RE: PETITION NO. 1438 - Bloom Energy Corporation petition for a declaratory ruling, pursuant to Connecticut General Statutes §4-176 and §16-50k, for the proposed construction, maintenance and operation a customer-side 500-kilowatt AC fuel cell facility and associated equipment to be located at 69 (a/k/a 65) Woodland Street and a customer-side 500-kilowatt AC fuel cell facility and associated equipment to be located off of Drake Hill Road, both located at the Dyno Nobel campus in Simsbury, Connecticut.

Petition No. 1438 Bloom Energy Corporation Dyno Nobel campus 69 (a/k/a 65) Woodland Street & off of Drake Hill Road Simsbury, Connecticut

Interrogatories - Set I

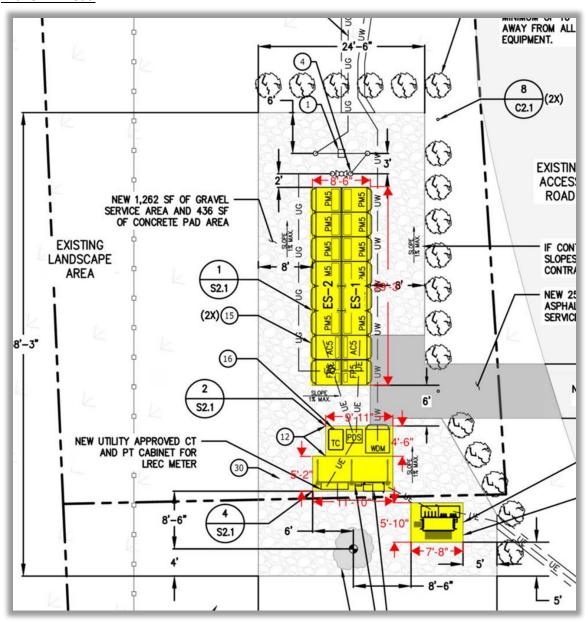
1. Would the proposed fuel cells and/or associated equipment be installed on concrete pads? If so, please provide the location and dimensions of the concrete pads on the site plans.

Yes, all equipment will be anchored to concrete pads. Amended site plans including the pad dimensions and other distances are provided as Attachments 1a and 1b. See figures below for specific dimensions of each proposed pad.

DETAILED SITE PLAN

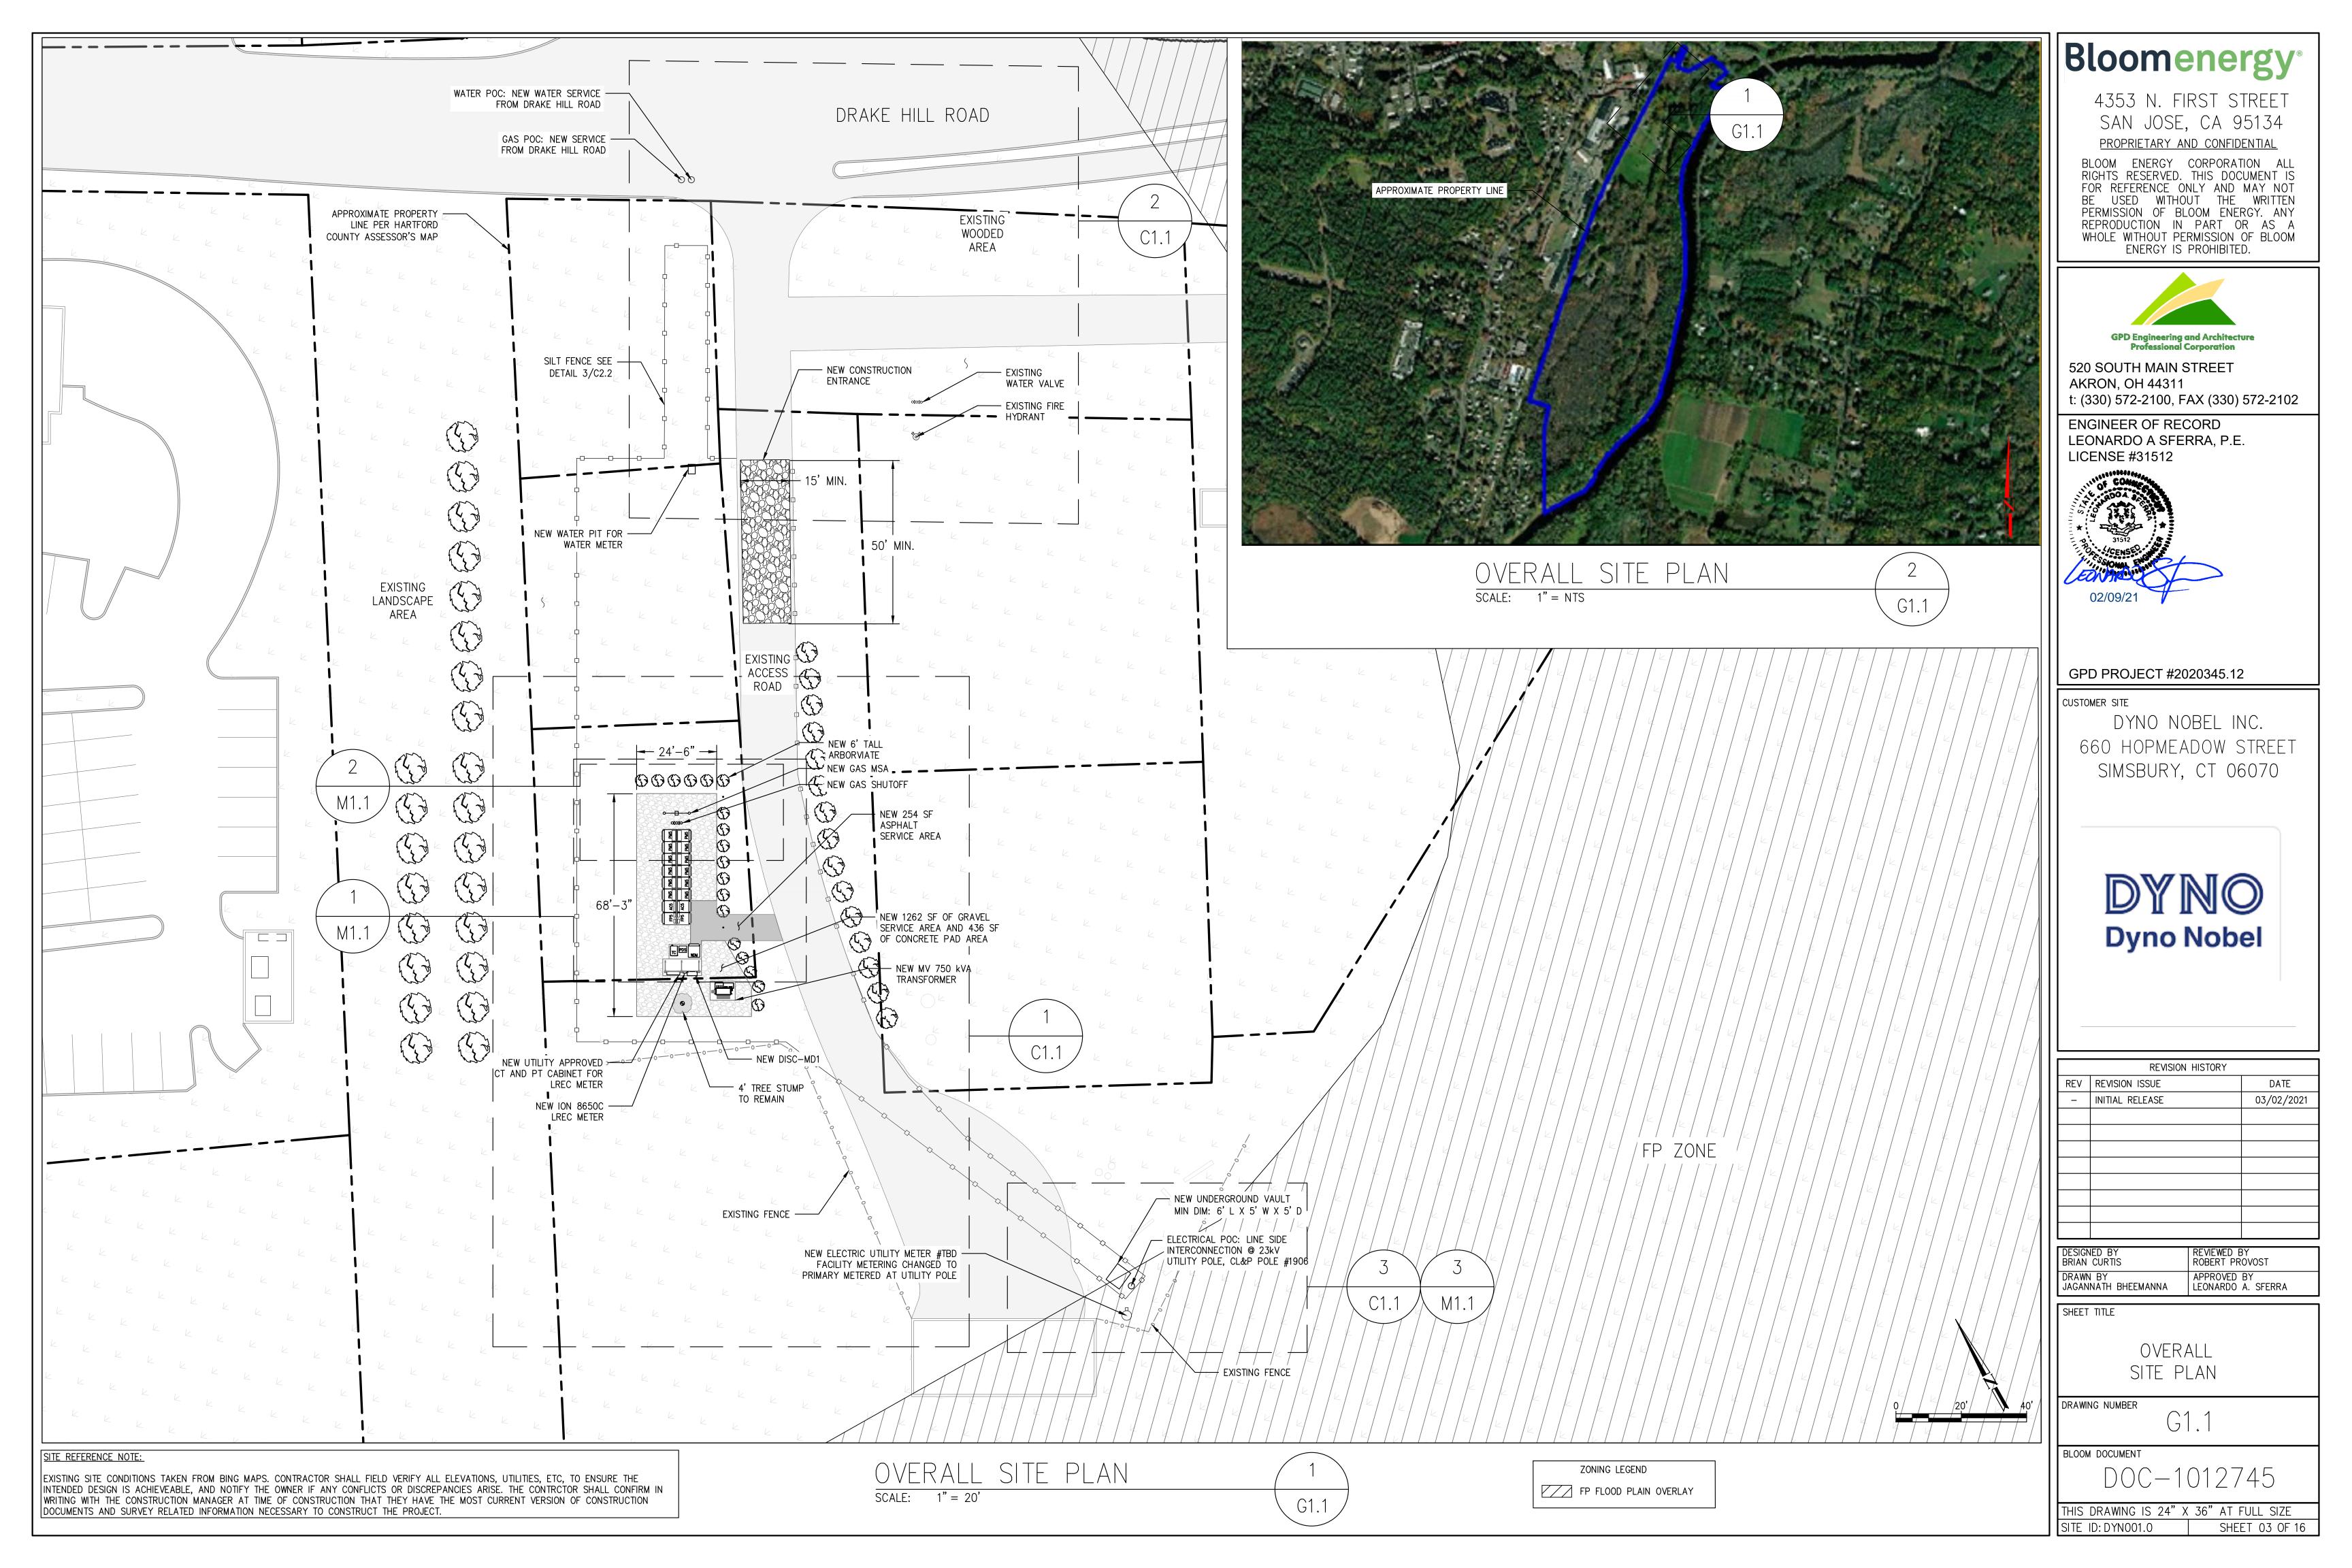
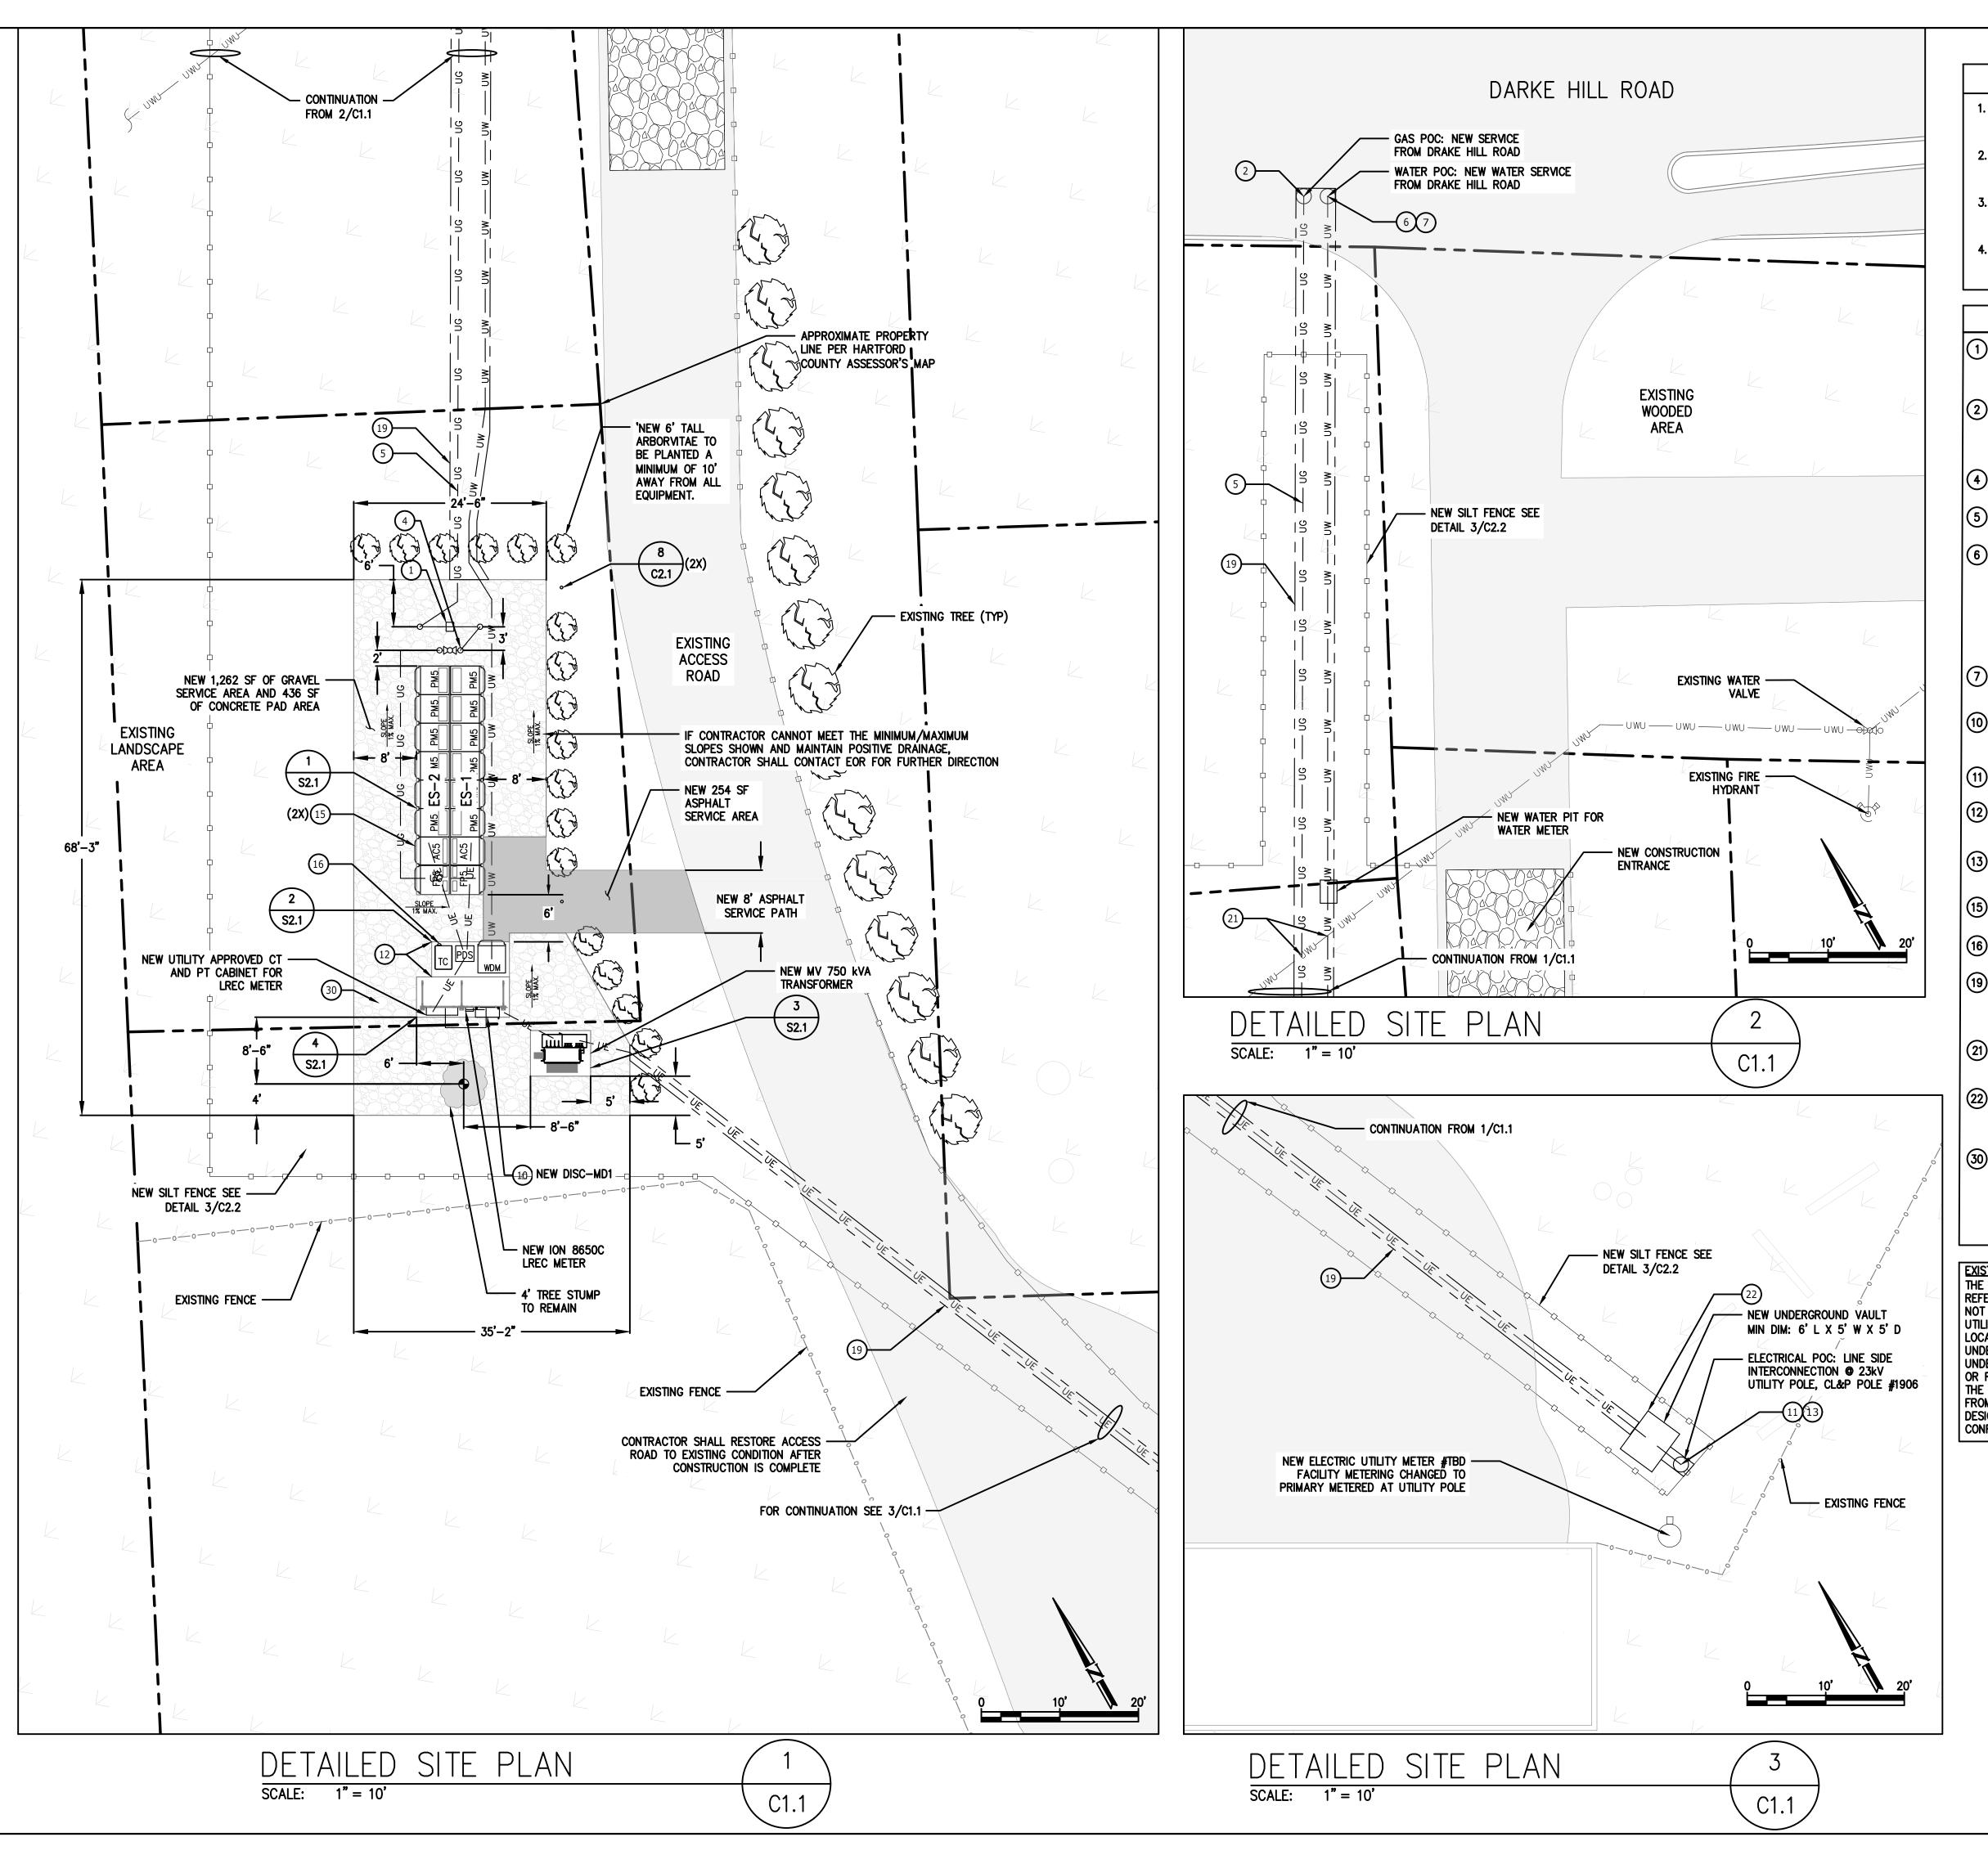
- 9. Referring to page 10 of the Petition, views of the Site 2 facility are expected from adjacent residential and commercial properties, Drake Hill Road and the Farmington Canal Trail. Could landscaping be installed along the eastern and northern boundaries of the facility to provide visual screening of the facility from adjacent properties?

- Response: Bloom has revised the plans for Site 2 and is proposing the installation arborvitae on the northern and western sides of the proposed Facility.
